Comment #5  
Increase Max Delay Constrain for  
40GBaseR PMA by 200ns

Farzin Firoozmand

Jul 13,2010

# Proposed 802.3bg PMA delay constrain must accommodate 40G Base-FR PMA 4:1

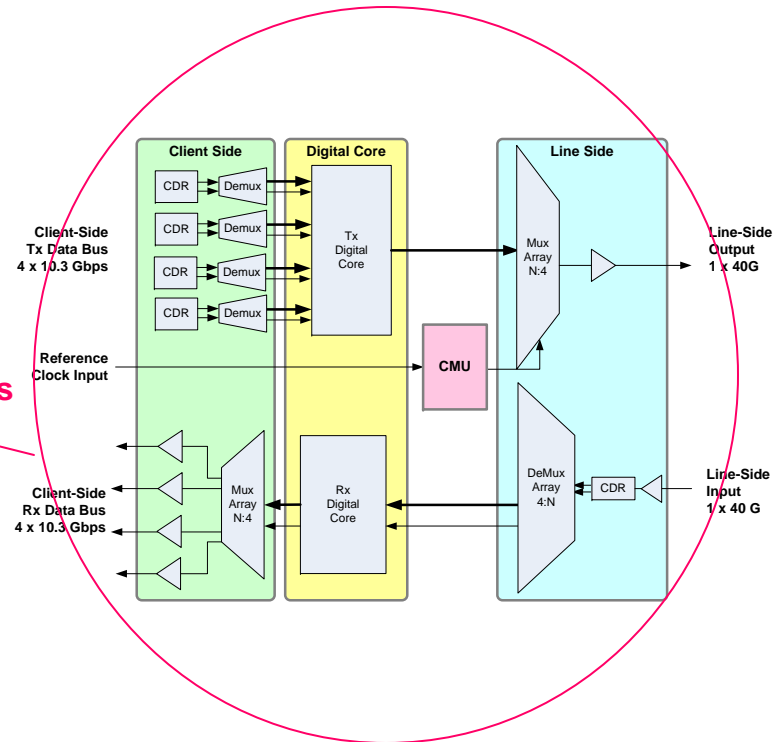
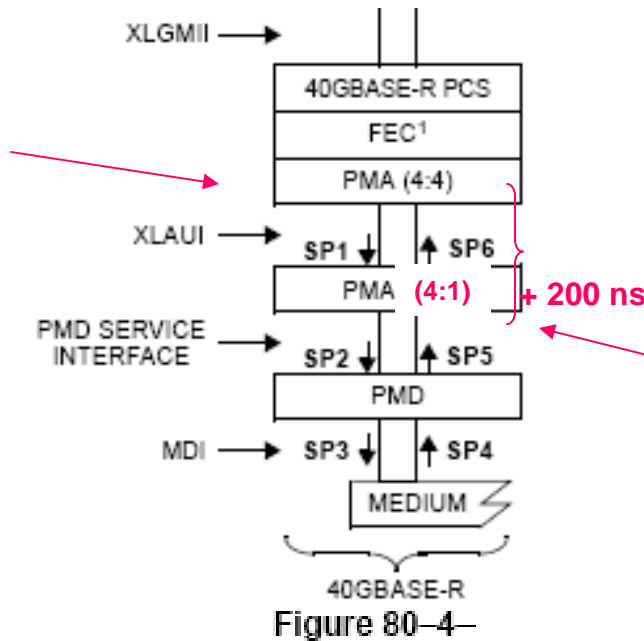
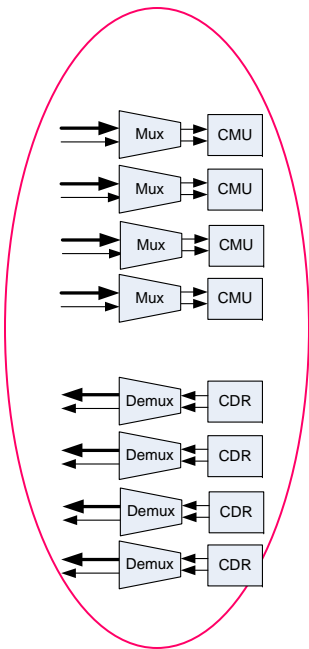
Typical FR implementation includes 2x10Gmux/demux, 1x40G mux/demux, at least 2 x10G CDRs and 1 x40G CDR, and a digital core w/ FIFO

*The 4:1 PMA implementation looks like a two-stages of 1<sup>st</sup> PMA (4:4). The delay from 4:1 PMA should be budgeted as twice as existing PMA*

- Increase the 40GBaseR PMA max delay constrain by 200ns
  - Allows vendors to optimize implementations for low power or low latency

# 40GBase-FR PMA delay constrain

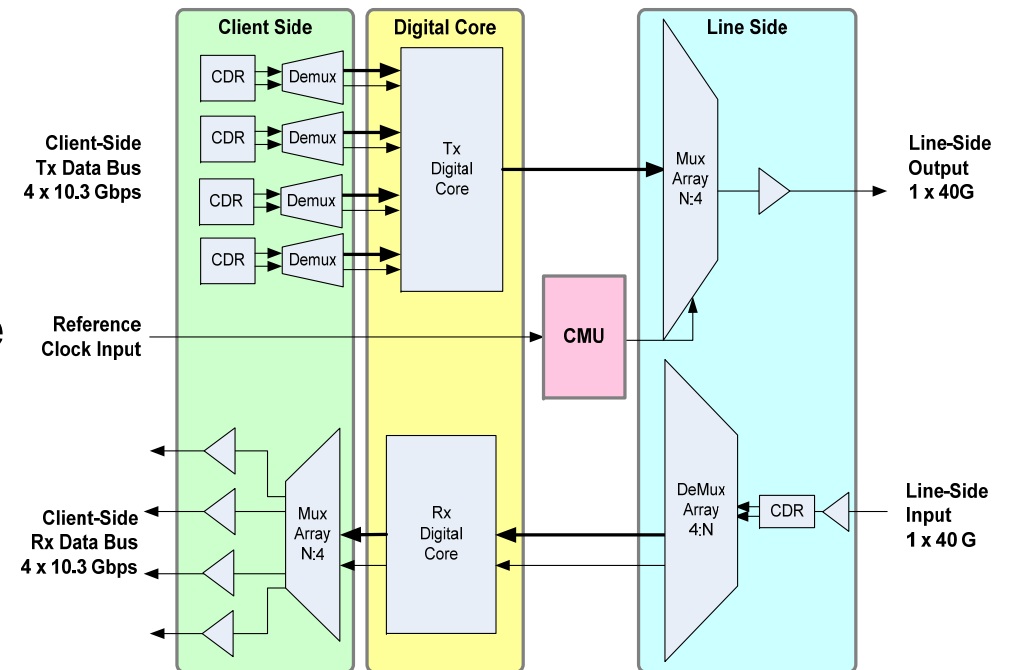
- Digital core is needed for rate adjust FIFO and deskew logic
- The width of the digital core defines the speed and power of the implementation
- Small delay constrain will force high speed, high power implementations
- The max delay constrain should allow for low power implementation
